PRODUCT / PROCESS CHANGE NOTIFICATION

1.1 Company		STMicroelectronics International N.V
1.2 PCN No.		APG/15/9167
1.3 Title of PCN		VIPower M05 in PSSO-12 (Deep Down Set): Activation of Shenzhen as Additional Assembly and Testing Location
1.4 Product Category		see list
1.5 Issue date		2015-04-10

VIPOWER M05 in PSSO-12 (Deep Down Set): Activation of Shenzhen as Additional Assembly and Testing Location

PSSO Strip Test Introduction

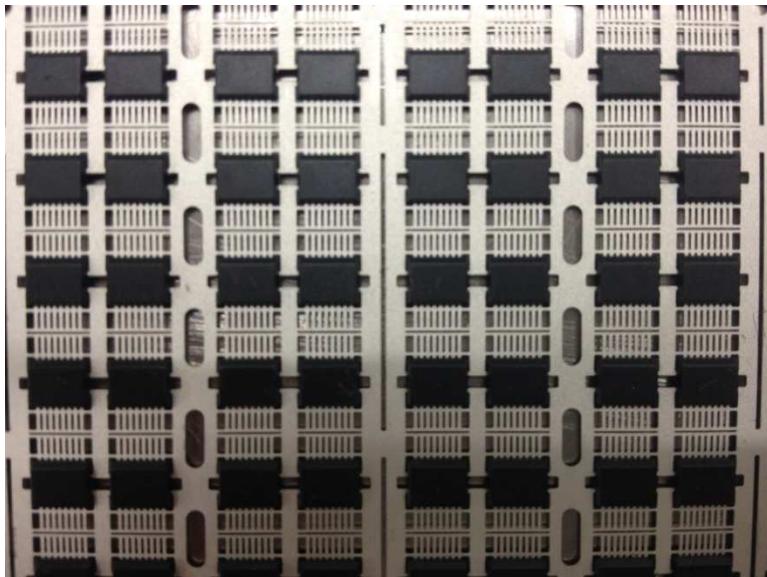
- Strip test is a new testing methodology that does not impact fit, form and function nor reliability of the products.
- Materials and equipments are not changed neither at FE nor at BE level
- Strip test is performed in between 1st crop (dam-bar cut) and 2nd crop (Trim&Form and final singulation)
- Further test step at ambient temperature is inserted after vision check

Leadframe before and after 1st crop

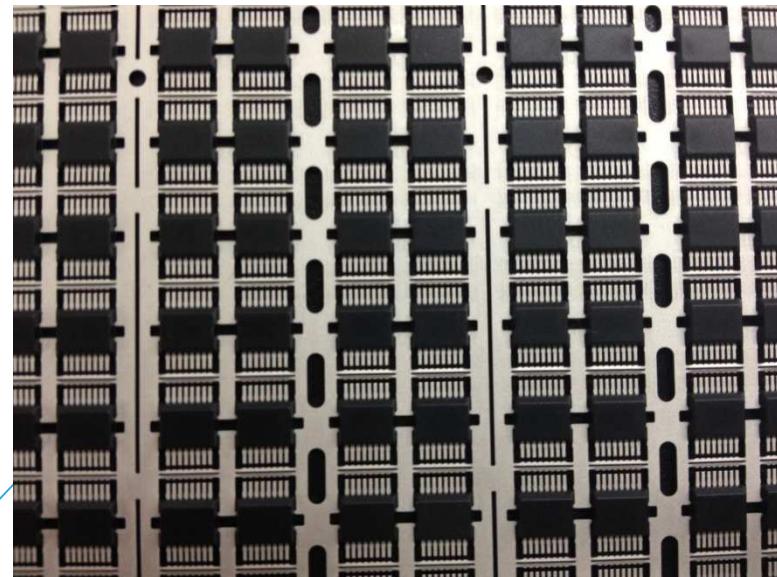
Dam-bar in between leads is cut during the 1st crop
As consequence pins are singulated
